P. O. A. D. P.

SUMMIT OAKS SUBDIVISION

RE: Summit Oaks POADP
File #282

The Development Review Committee reviewed your plan for Summit Oaks Subdivision. The plan has been assigned File #282 for future reference.

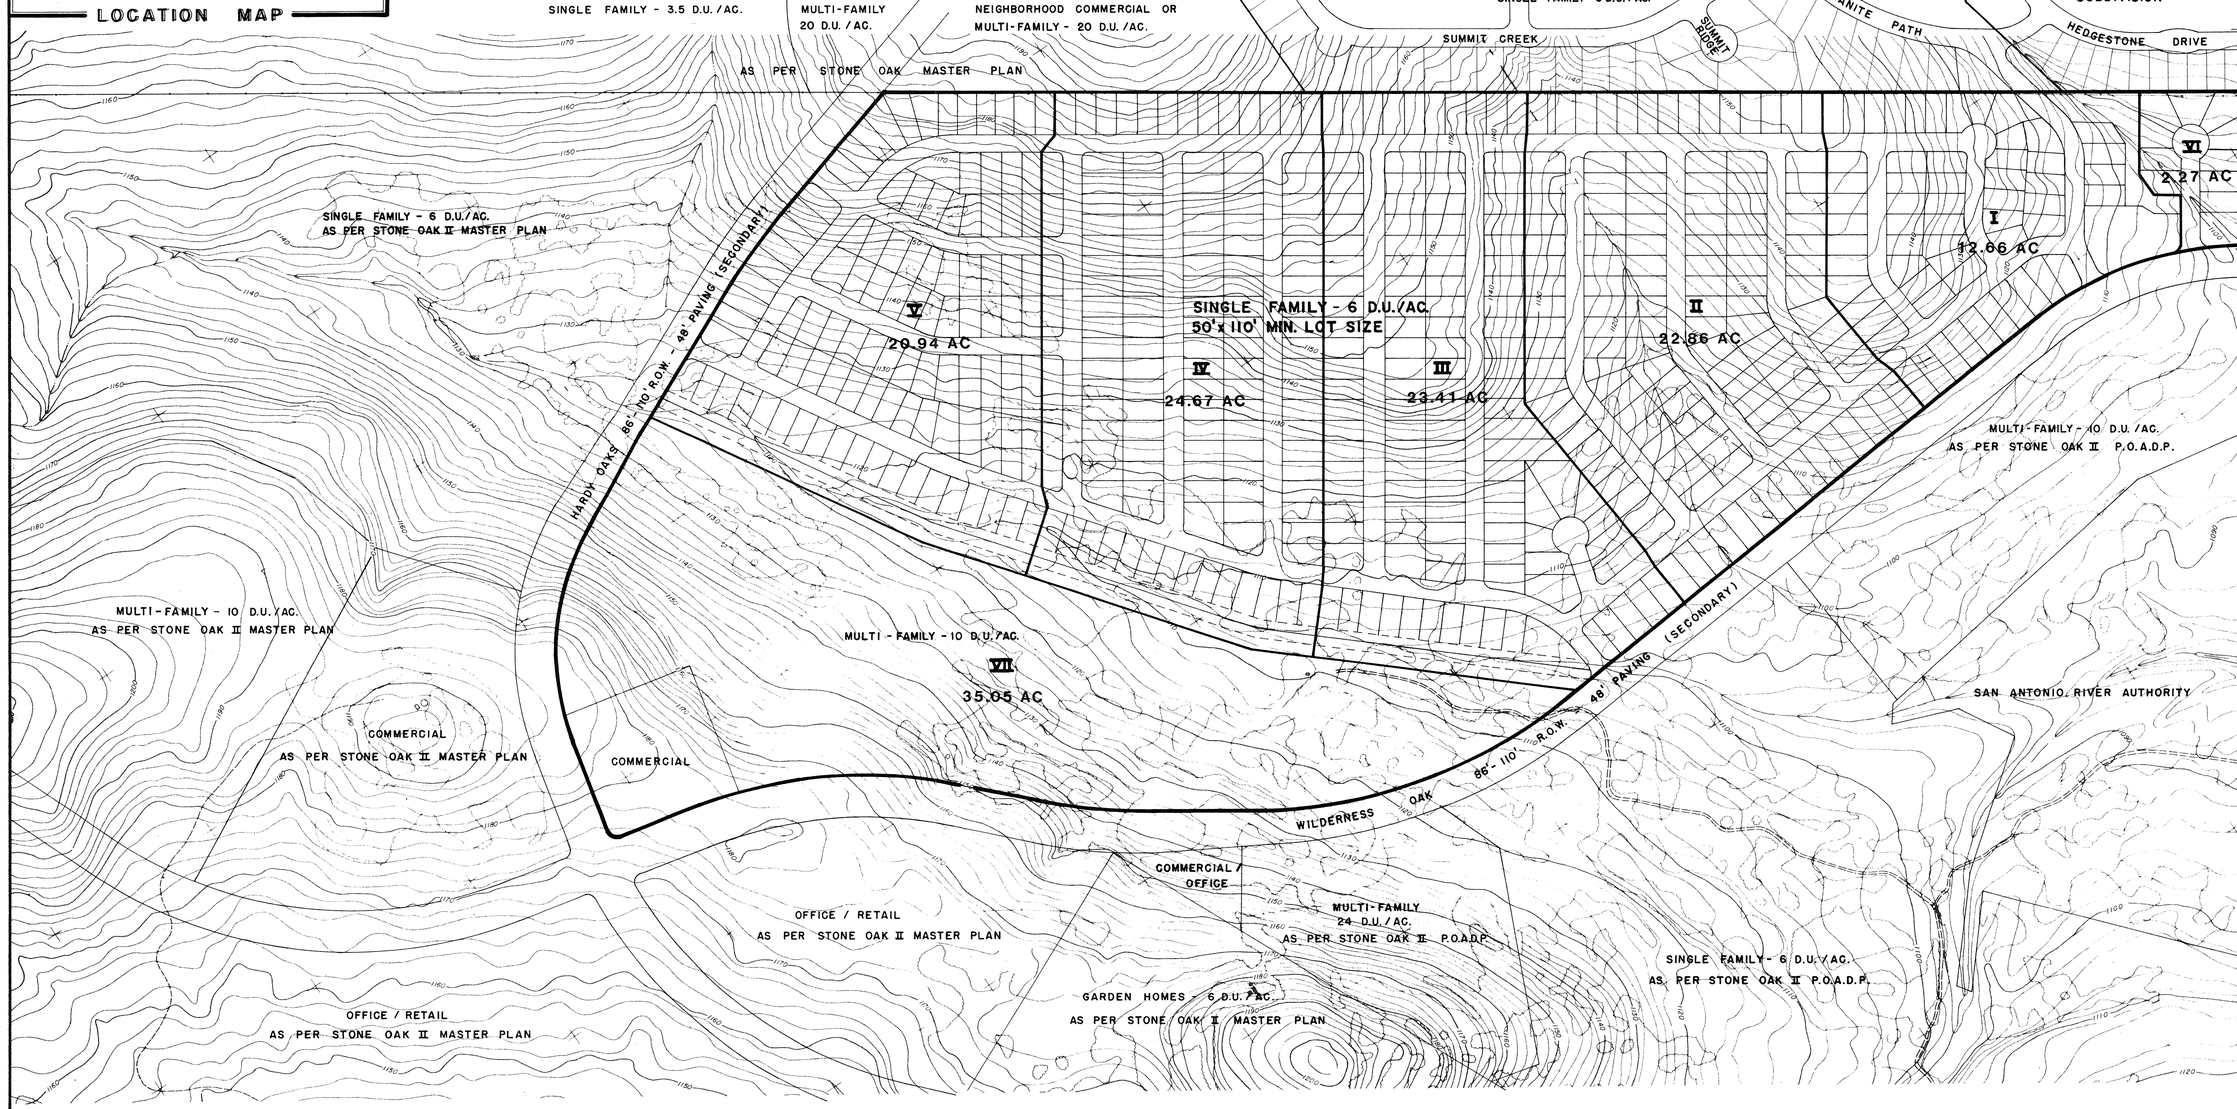
1. We recommend you consider a more circuitous alignment for the street which parallels the proposed multifamily area through phases III, IV, and V. This street as proposed would offer a direct link between Hardy Oaks and Wilderness Oak, bypassing the intersection of these two thoroughfares. We foresee a considerable amount of through traffic using this residential street.

2. The accepted POADP for the Summit at Stone Oak on file with our office does not reflect a stub out to your development from Granite Path. We therefore request you delete the stub out shown in Phase I of your plan.
